Doors & Hardware

Drywall

Acoustical Ceiling

1		RFI 01	3/31/22
REV	APPROVED DATE	DESCRIPTION	JCN REDLINE DATE APVD
DEPARTMENT OF TRANSPORTATION FEDERAL AVIATION ADMINISTRATION ATO - TECHNICAL OPERATIONS WESTERN SERVICE AREA			
ARTCC RECONFIGURE M1 ROOM MAIN FLOOR PLAN			
PALMDALE		LOS ANGELES CTR CA	
REVIEWED BY	SUBMITTED BY	APPROVED BY	
	ART GAPASIN PROJECT ENGINEER	DARYL KITCHEN MGR. ENGINEERING - LA	
DESIGNED	KDL	ISSUED BY	DATE 02.04.2021 JCN 1004394
DRAWN	KDL	ENGINEERING SERVICES	DRAWING NO
CHECKED	SJP	ENROUTE/FSS	ZLA-D-ARTCC- A101

C8 DOOR AND FRAME TYPES
1/4" = 1'-0"

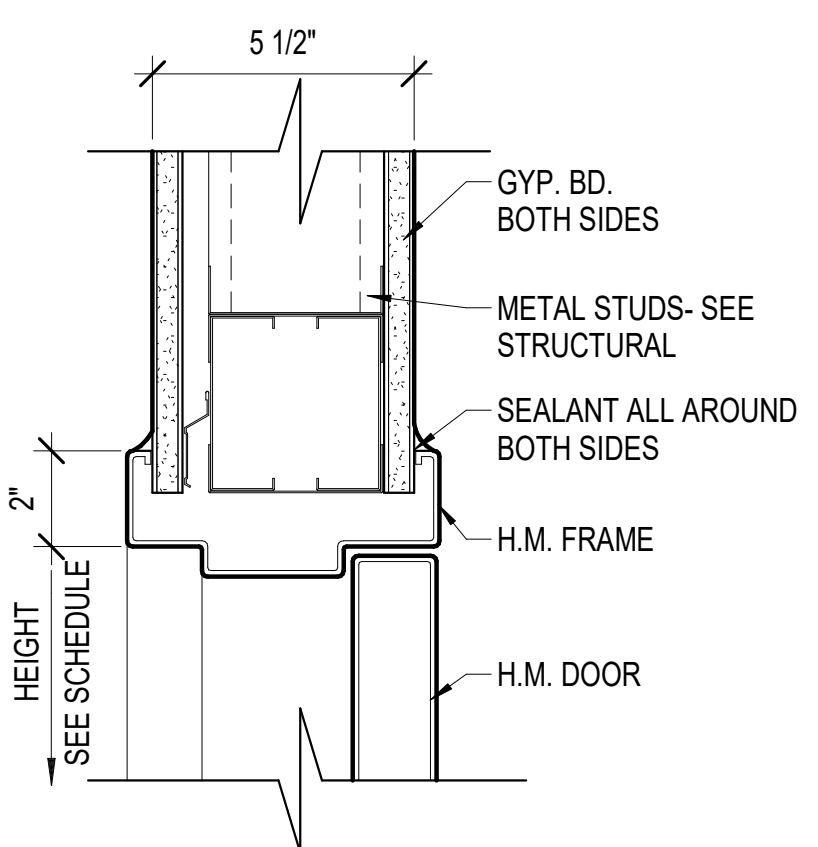
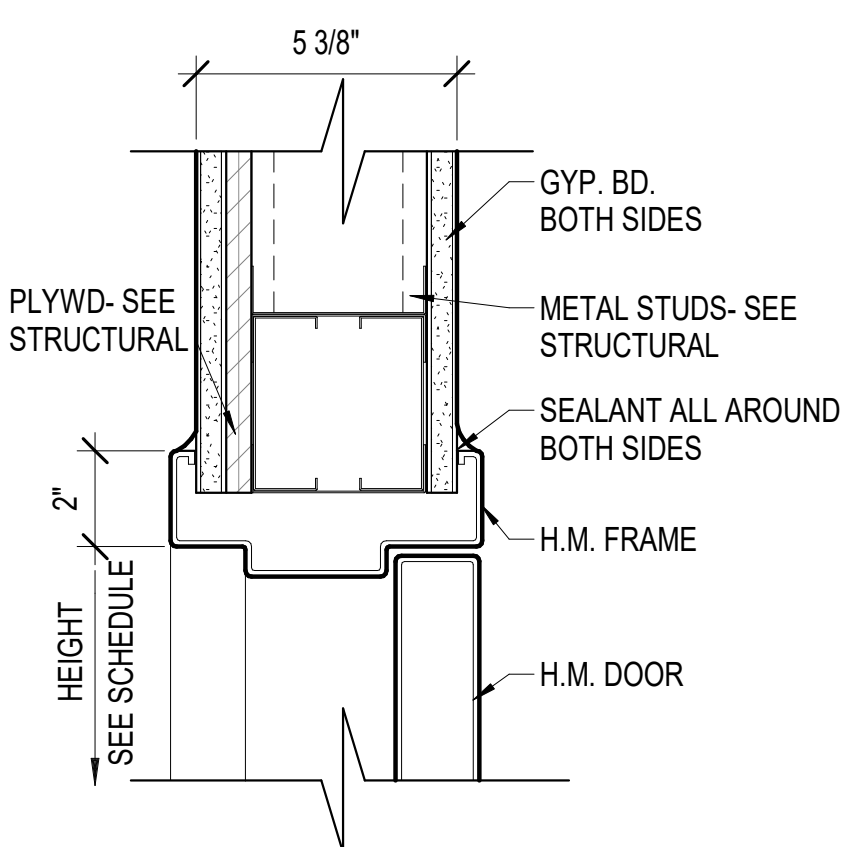
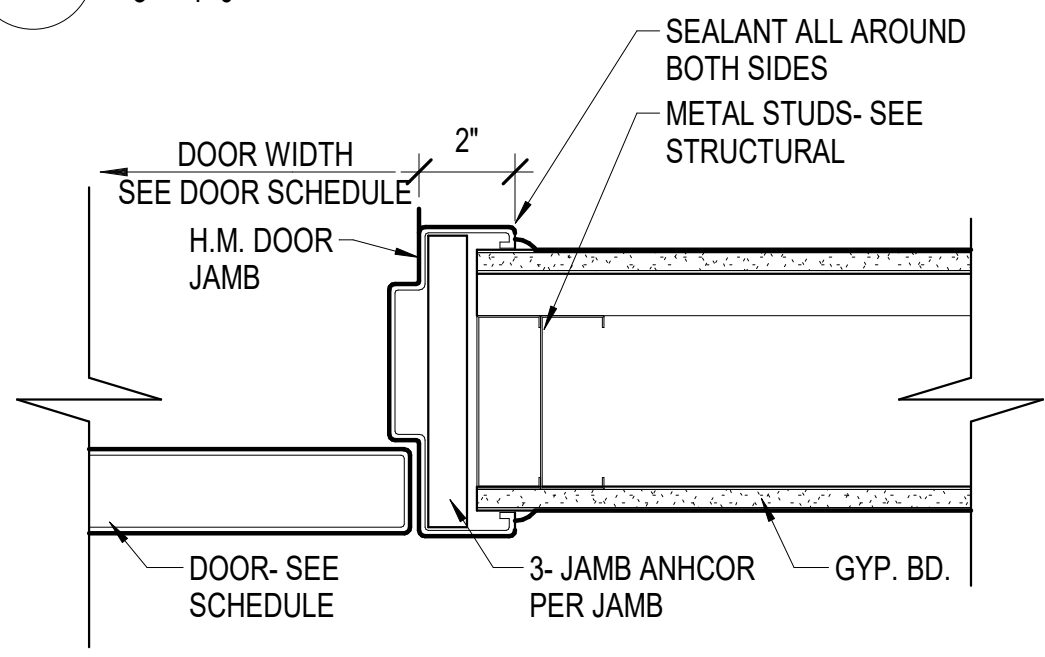
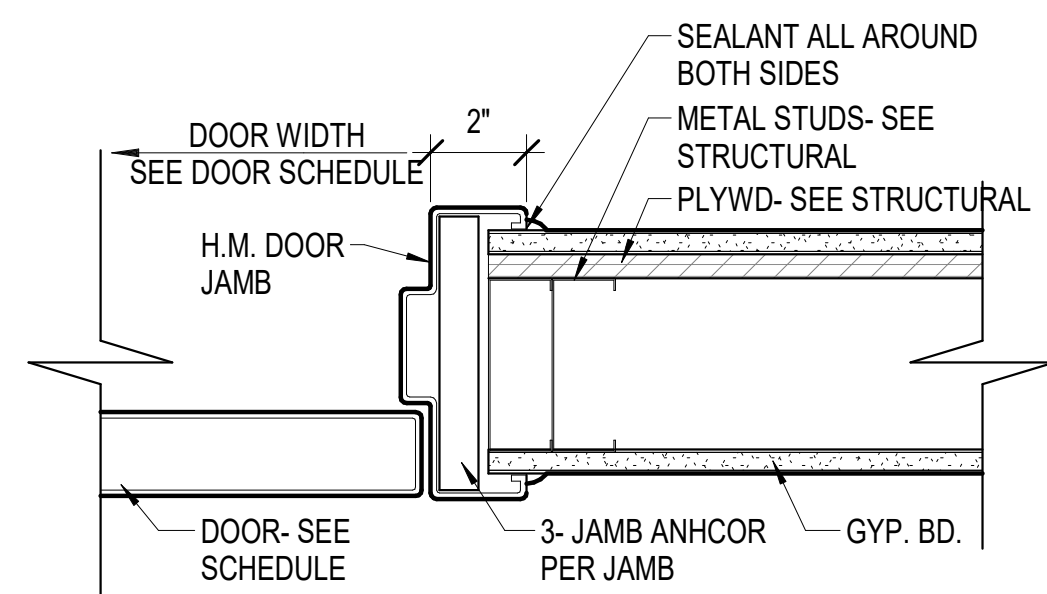
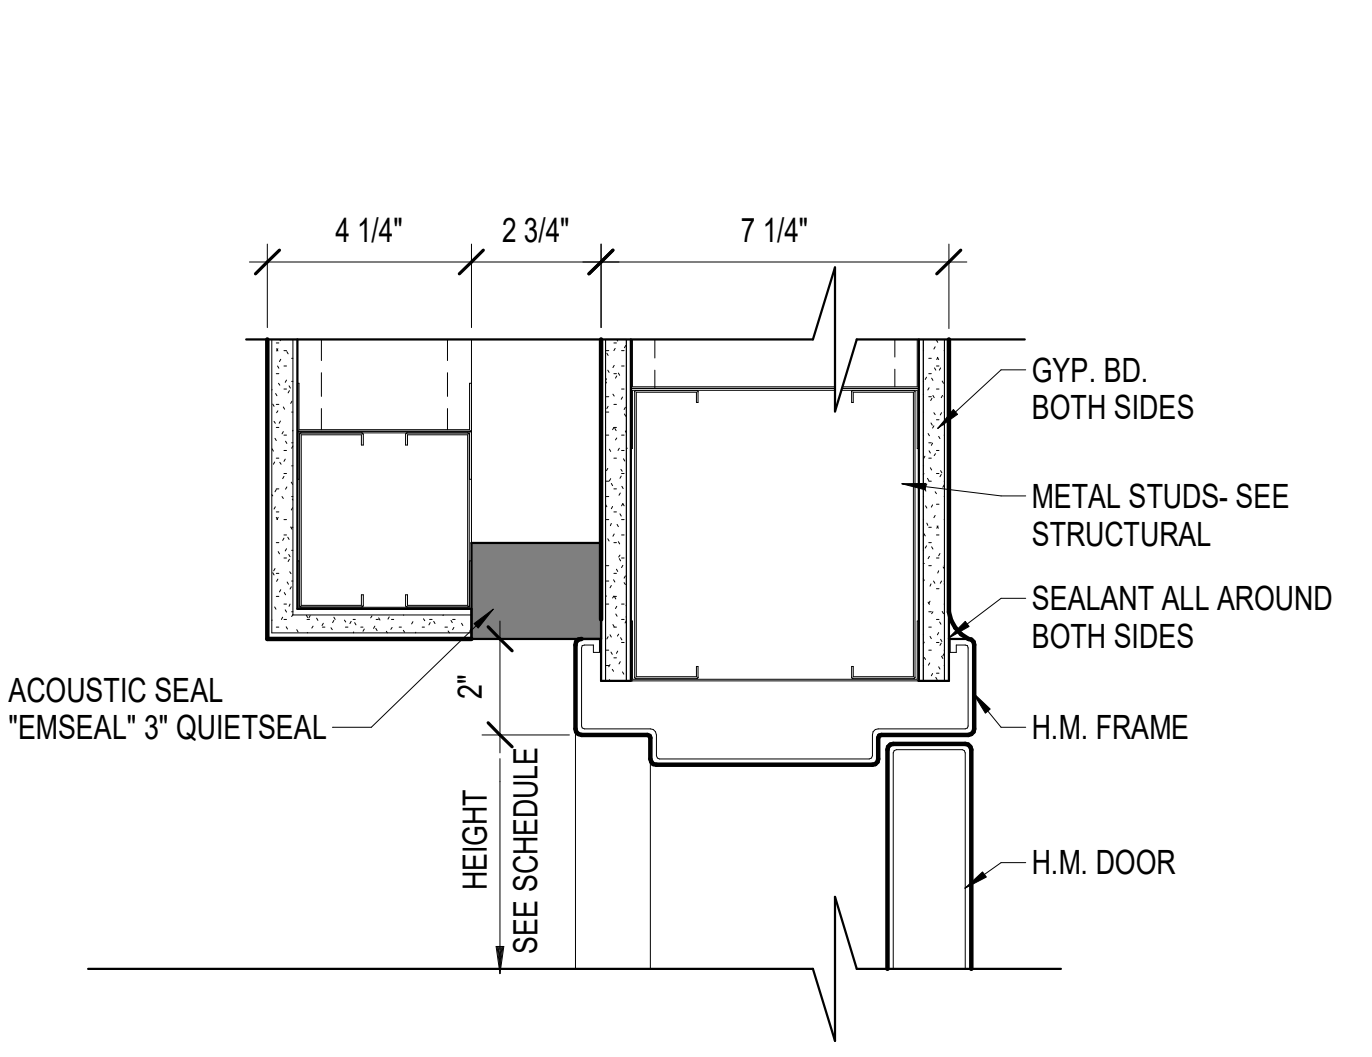
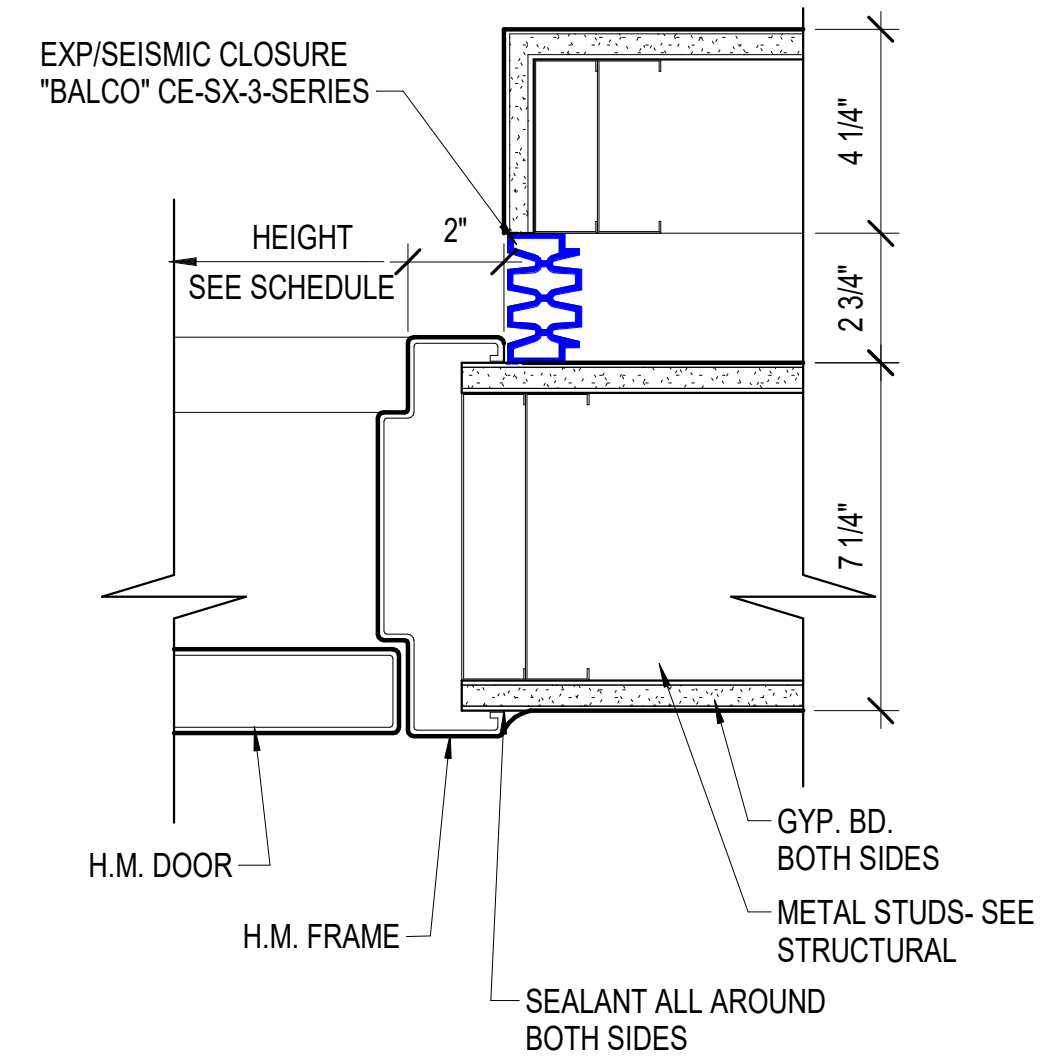
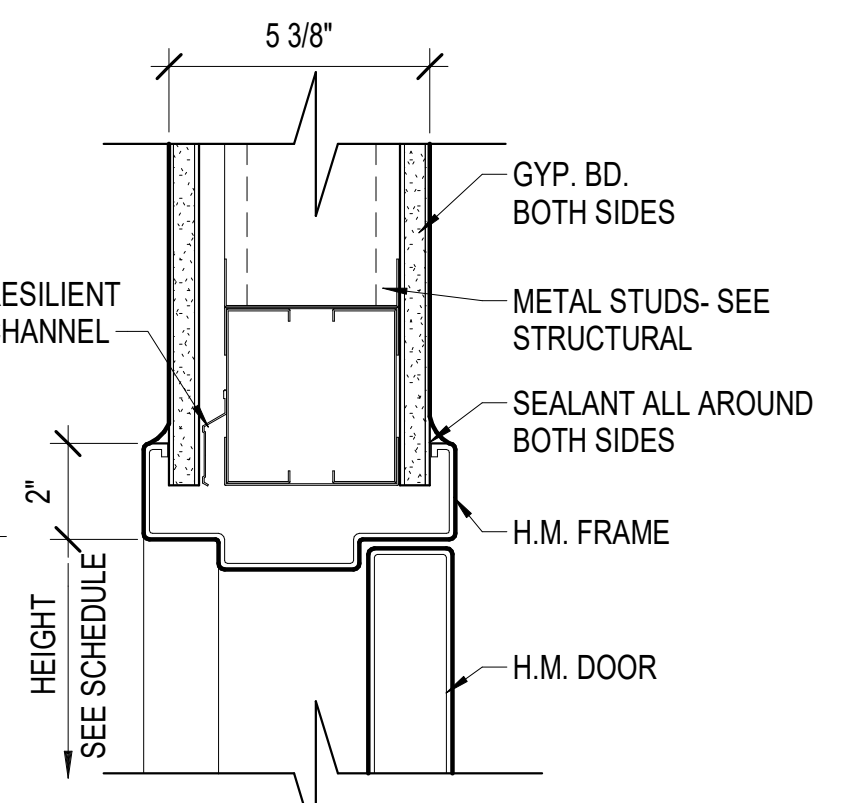
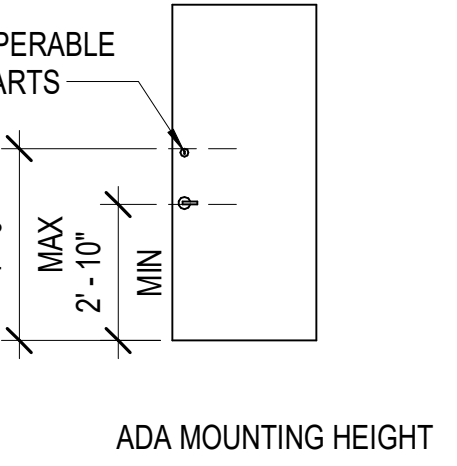
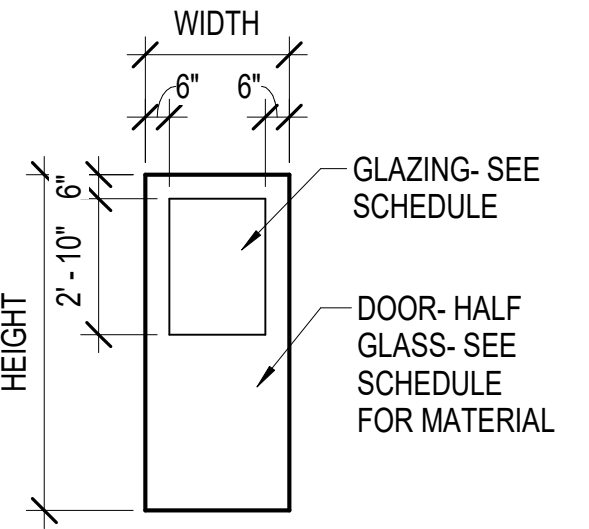
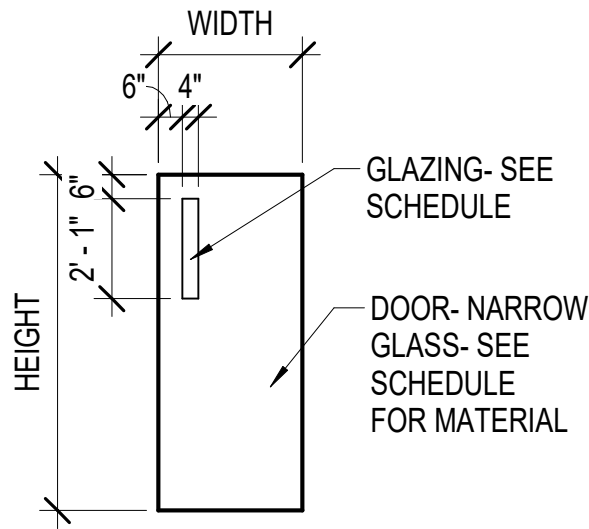
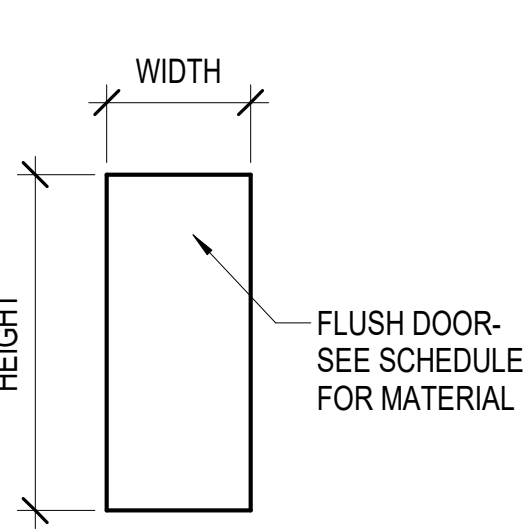
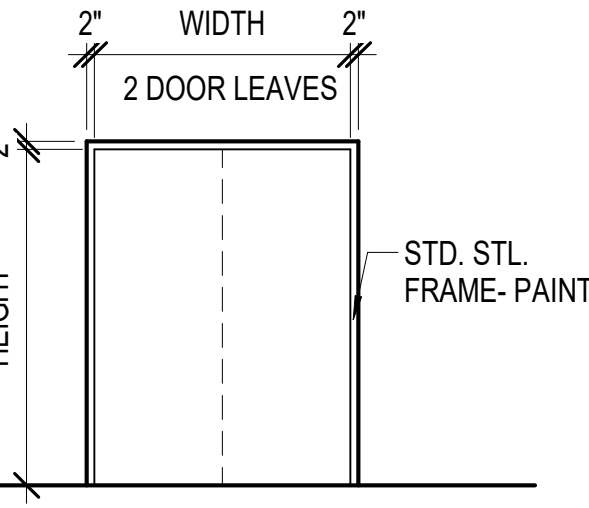
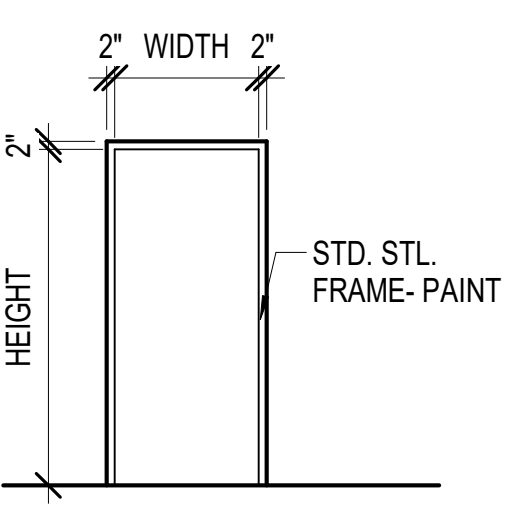
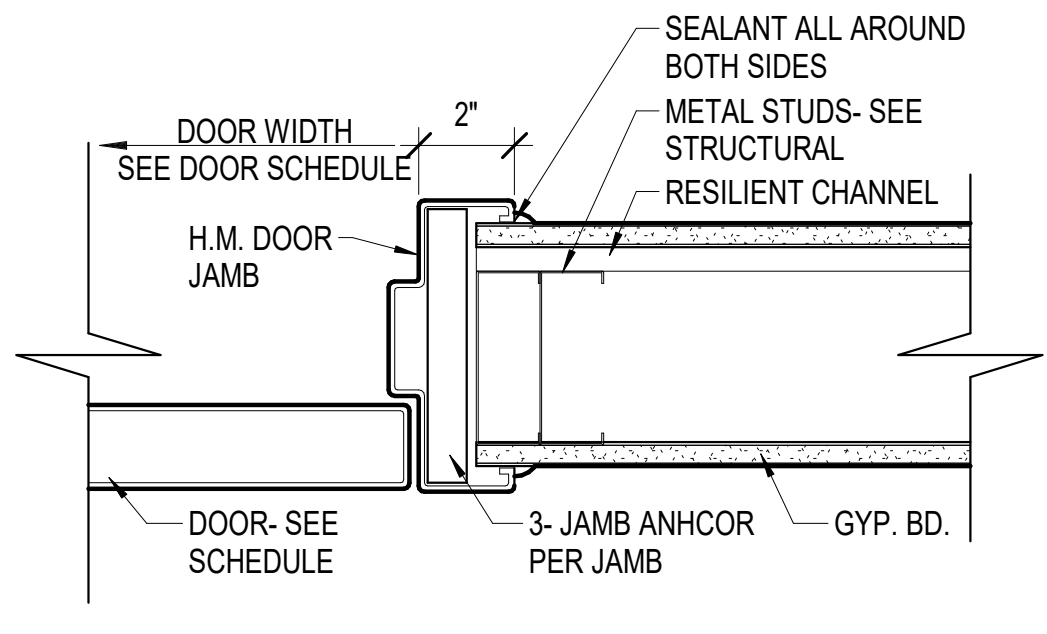
1. The door schedule indicates the hardware groups are in the spec. we cannot find hardware groups in the spec nor does the door schedule list the hardware group for each door. Can you provide this information. – **See revised A601 and Spec 08710.**
